Origination Form

Proposed Revisions to a Standard Plans Index

| Originator: | Turley, Joshua | Index Number: | 521-650 |
| E-mail: | Joshua.Turley@dot.state.fl.us | Index Title: | LIGHT POLE PEDESTAL - WALL COPING |

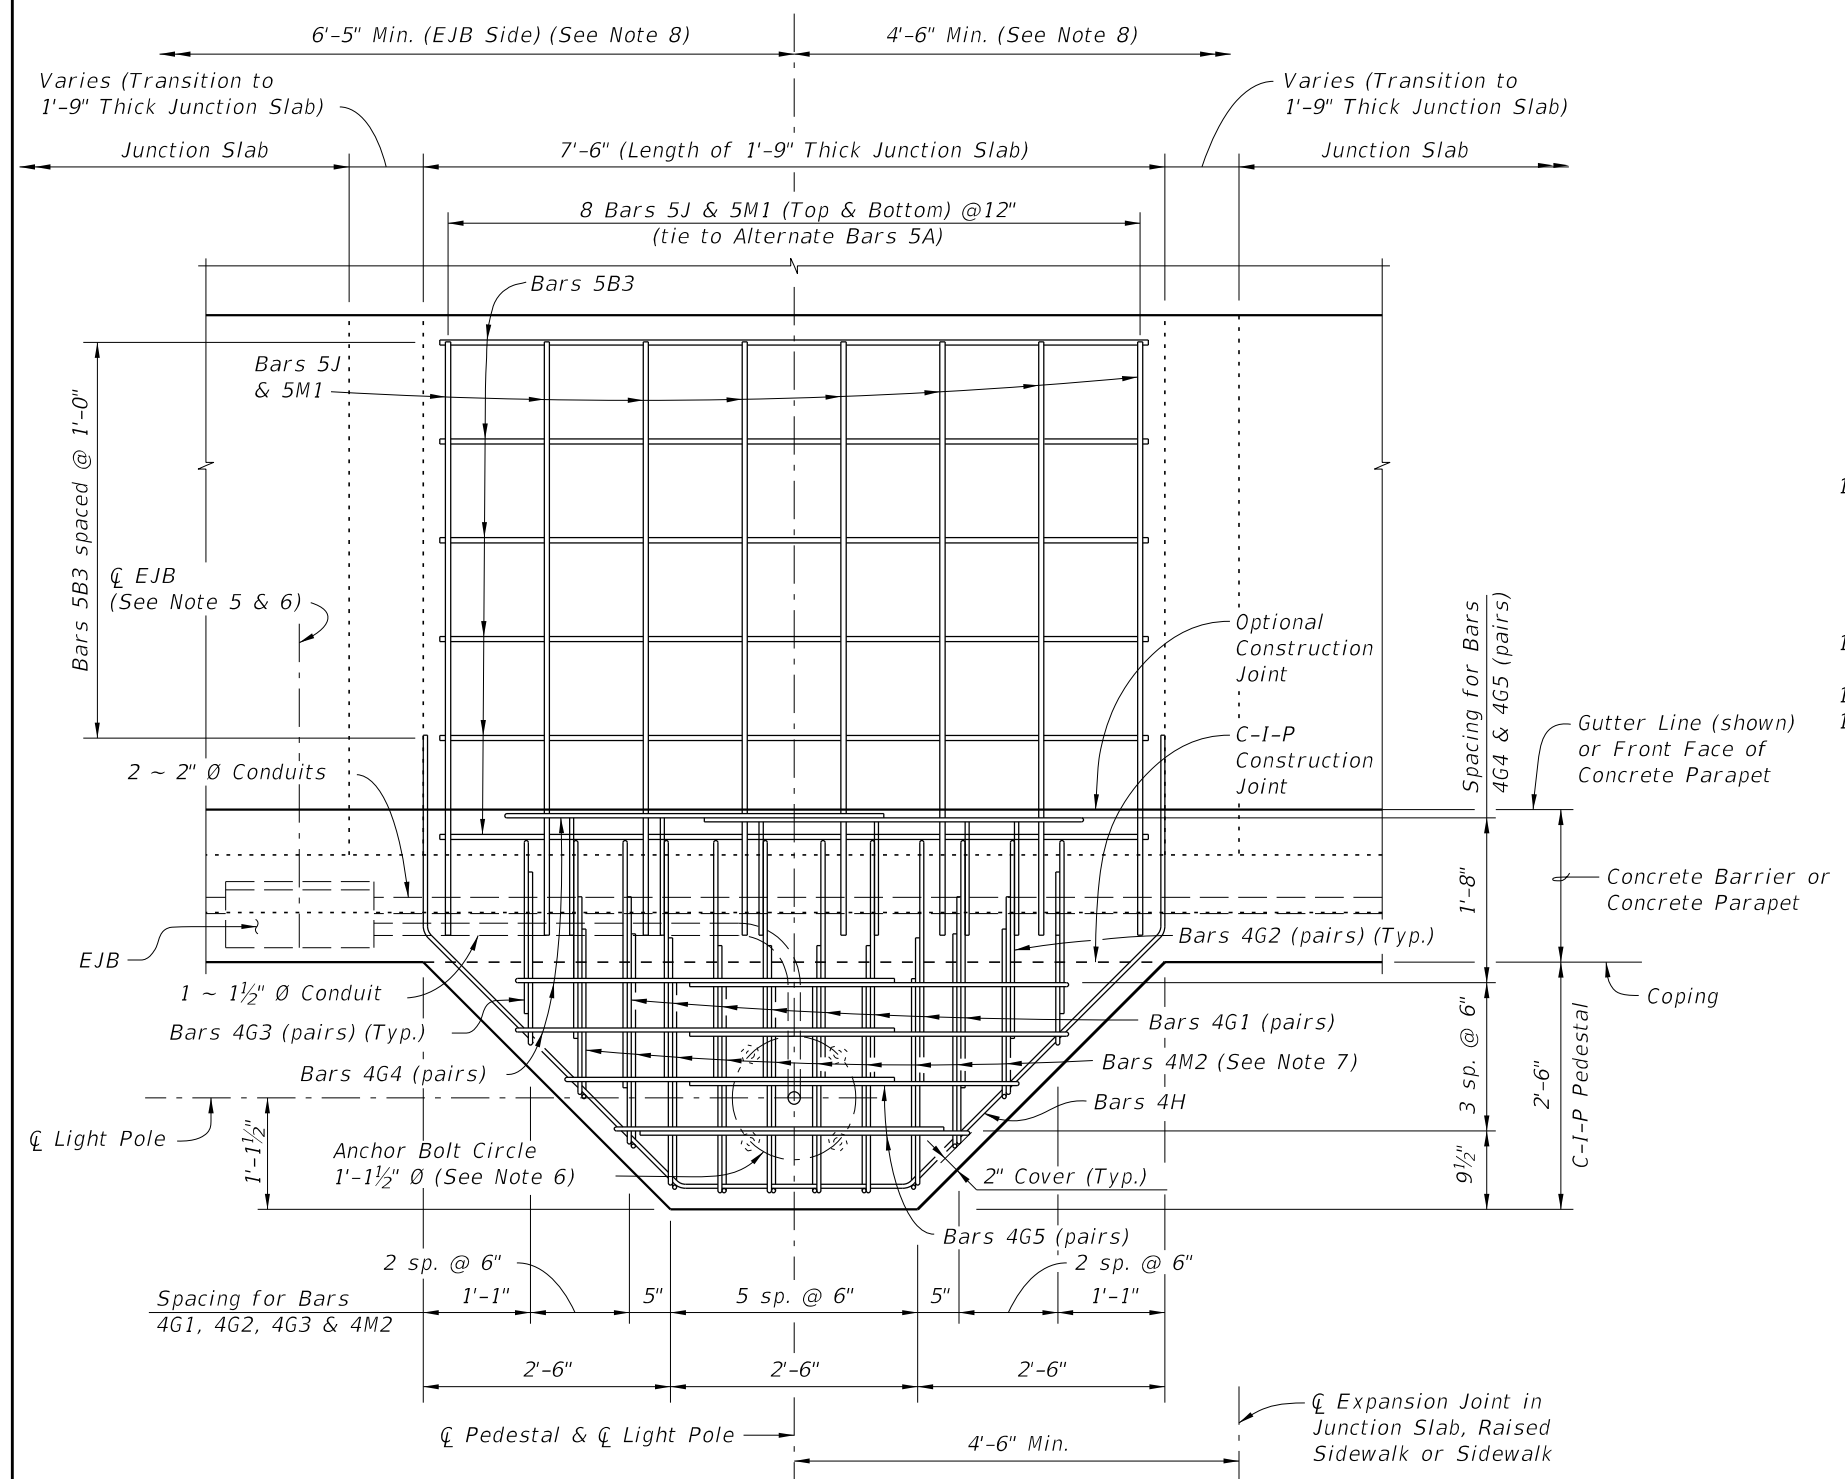
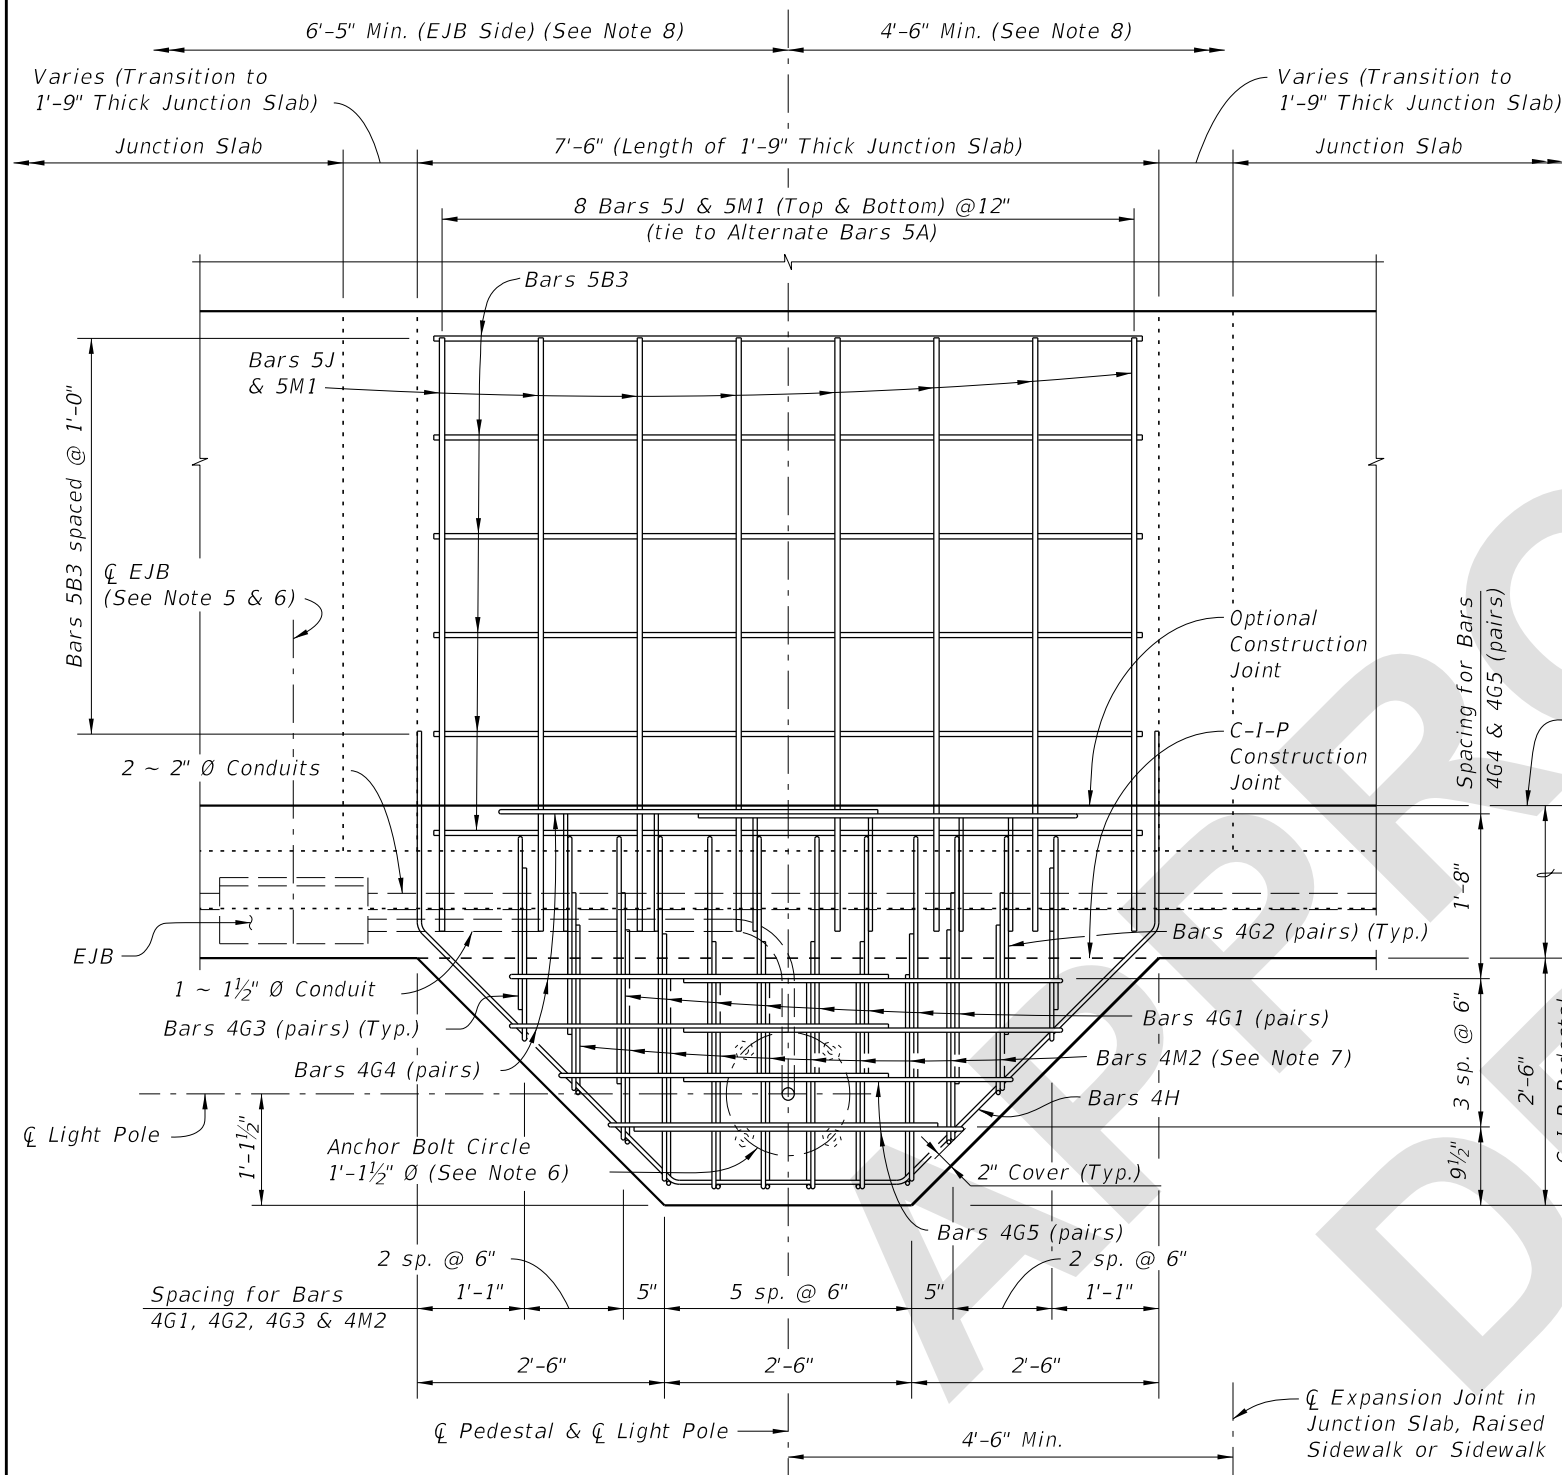
Sheet 1: Removed anchor bolt table; Revised note 1 to now include maximum deck height, pole height, and pole arm length
 Sheet 3: Added labeling to the Anchor bolt nuts in DETAIL "A"

Sheet 1: The anchor bolt table was removed so that this Index will only address the standardized pole and pedestal capacities. The pole mounting height is limited to 40 feet for an elevated structure mount.
 Sheet 3: Labels were added to correspond correctly with upcoming spec change to Spec 649.

- ANCHOR BOLTS:**
Anchor Bolt design is based on the standard Roadway Aluminum Light Pole configurations shown on Index 715-002 with top of pedestal 75' or less above ground or MLW.
~~Anchor Bolt Diameter: See Table 1~~

~~TABLE 1 DESIGN LIMITATION FOR ANCHOR BOLTS (1" Dia.)~~

with a maximum 40 ft luminaire mounting height and a maximum 12 ft arm length. Use 1" Ø anchor bolt for up to 75 ft bridge deck height above natural ground or MLW.

1. ANCHOR BOLTS:
Anchor Bolt design is based on the standard Roadway Aluminum Light Pole configurations shown on Index 715-002 with a maximum 40 ft. luminaire mounting height and maximum 12 ft. arm length. Use 1" Ø anchor bolt for up to 75 ft bridge deck height above ground or MLW.

DETAIL "A"

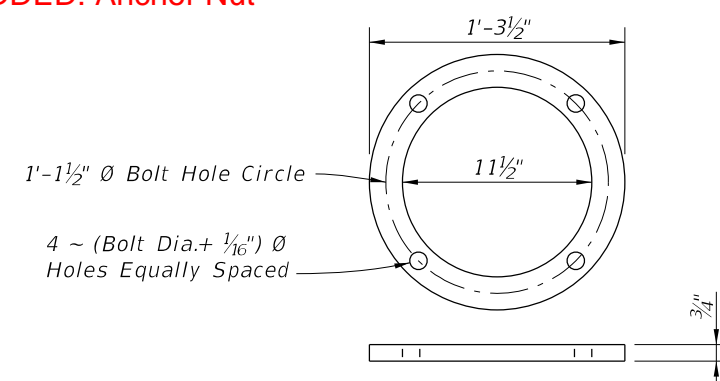
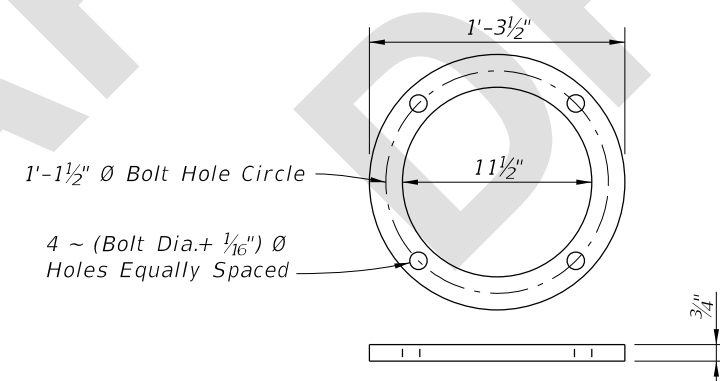
ADDED: Retainer Nut
ADDED: Anchor Nut
